Re: **Notice of Intent – AnyFence Co., 1485 Washington Street, Holliston MA,
DEP File#: CE 185-0931**

CDW has reviewed the comments by McClure Engineering, Inc. (McClure), dated September 27, 2022, regarding the Notice of Intent Stormwater Management Design for AnyFence Co. The Site Plan Set have been revised to address the comments from the McClure letter and have a revision date of October 18, 2022, and offer the following responses to the comments. The McClure comments are in bold. Additionally, the Conservation Commission requested additional plan revisions listed at the end of the comments.

Pond UGI: Underground Infiltration System - Chamber Wizard Field A

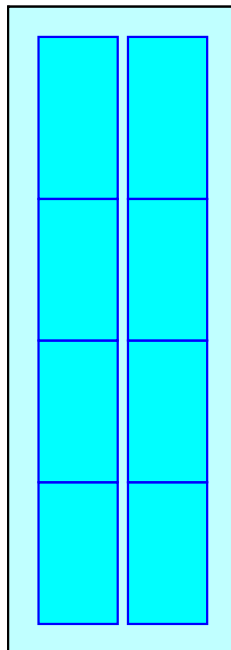
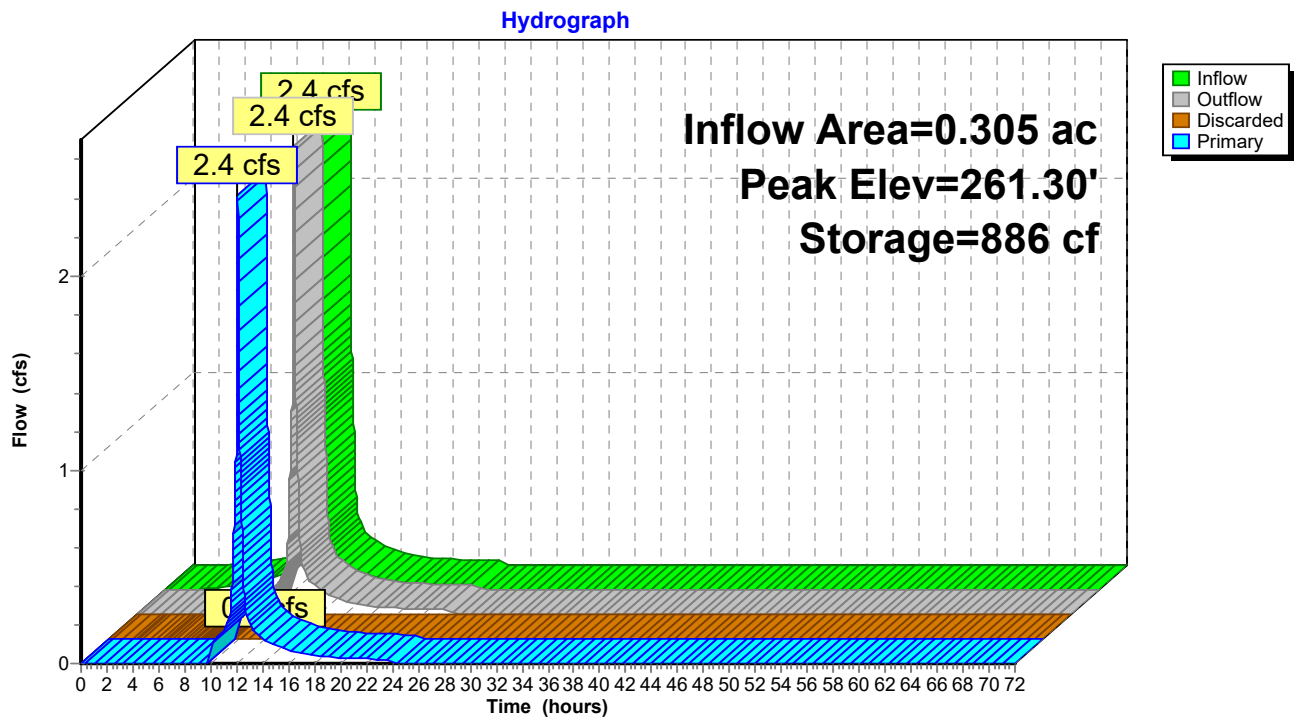
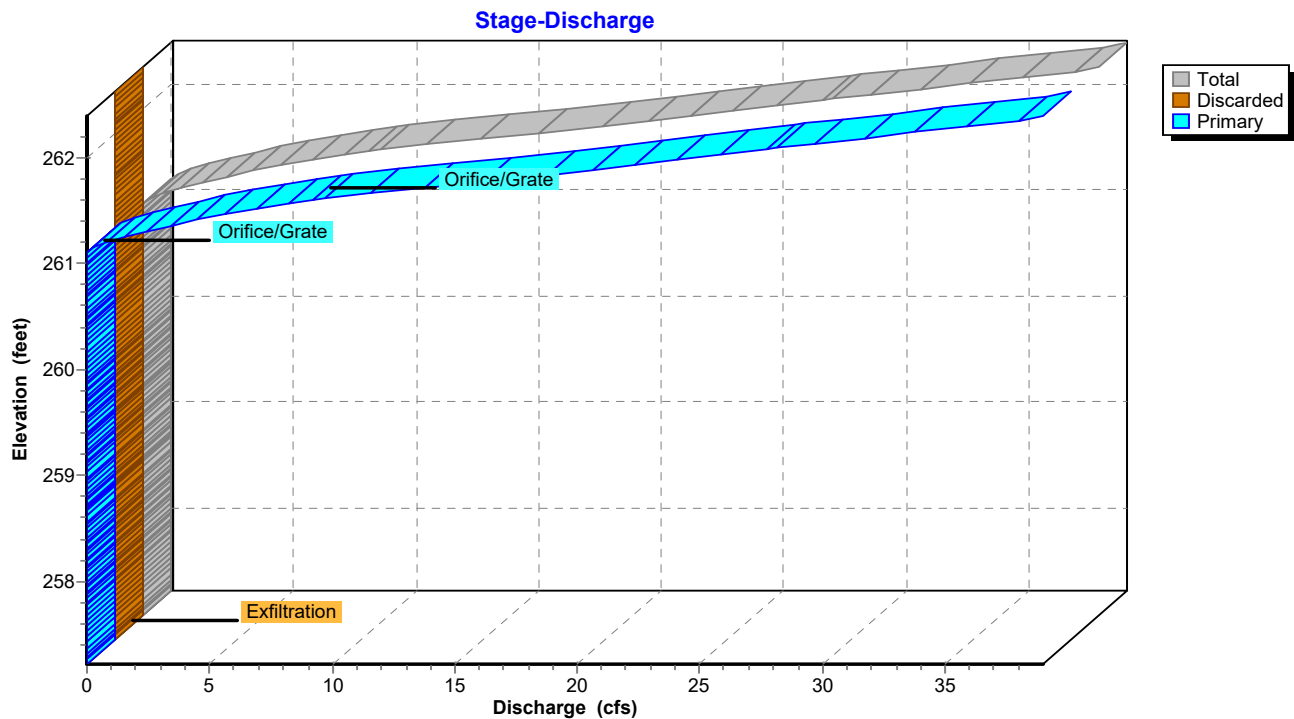
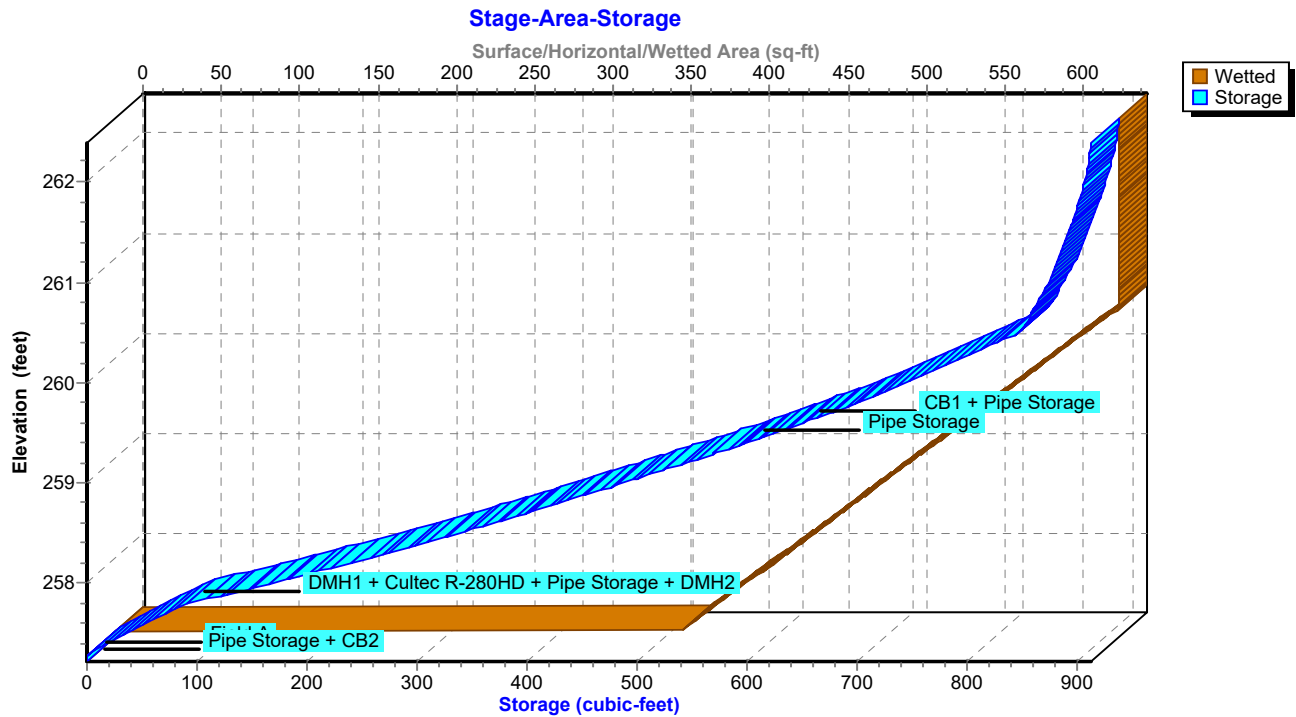
3. **Standard 3 - Ground Water Recharge Volume.** As a redevelopment project this standard needs to be met to the maximum extent practicable. No soil testing was conducted to determine estimated seasonal high groundwater, soil classification, or hydraulic conductivity. Soil mapping indicates "Udorthents" soil types, which are typically associated with fill. If fill is found to be present, the system shall be designed per the MA Stormwater Standards Manual Volume 3: "When fill materials are present or are added prior to construction of the system, a soil textural analysis must be conducted in both the fill material and the underlying parent materials, and the Hydrologic Soil Group of the more restrictive layer shall be used to size the infiltration BMP. If fill is present that is composed of asphalt, brick, concrete, construction debris, or if materials classified as solid or hazardous waste are identified at the specific location where recharge is proposed, recharge elsewhere on site must be considered. Alternatively, the debris or waste may be removed in accordance with all applicable Solid and Hazardous Waste Regulations (see 310 CMR 19.000 and 40.0000) and replaced with clean material suitable for infiltration. Any solid or hazardous wastes present on the site must be managed in strict accordance with MassDEP Solid Waste Regulations, 310 CMR 19.000, Hazardous Waste Regulations, 310 CMR 30.00, and the Massachusetts Contingency Plan Regulations, 310 CMR 40.000." Soil testing should be performed to ensure proper design of the infiltration system including depth to groundwater, infiltration rate, and drawdown. The proposed system is sized for the required recharge volume for only the impervious area directed to the system and not for the site. Although the proposal meets the standard for redevelopment and it is not required under the MA Stormwater Standards or Holliston Regulations, there is opportunity to bring the site into further compliance for required recharge of all impervious areas. The Holliston Land Disturbance regulations emphasize maximizing infiltration and groundwater recharge. A second story is proposed on a portion of the building and it is assumed a new roof drainage system will be constructed as part of this addition. This "clean" roof runoff could potentially be used to provide additional groundwater recharge without requiring pretreatment. McClure respectfully defers to the Commission.

A soil test was conducted on October 12, 2022 and a soil log is now included in the Stormwater Narrative. The test pit was excavated to a depth of 8.7 feet below ground surface. There was no presence of fill materials, and the soil type has been confirmed as a loamy sand. No groundwater or mottling was observed. Additionally, as an additional check of the underground system, the exfiltration rate for the chambers was modeled as 0.17 in/hr, equivalent to a Hydrological Group C, Sandy Clay Loam. Using the significantly lower infiltration rate, while there is a slight increase in the post development flow, it is still below the pre-existing runoff rates. The calculation using the lower infiltration rate for a 100-yr storm is included at the end of this letter, shows that the functioning of system is largely unaffected by the infiltration rate.
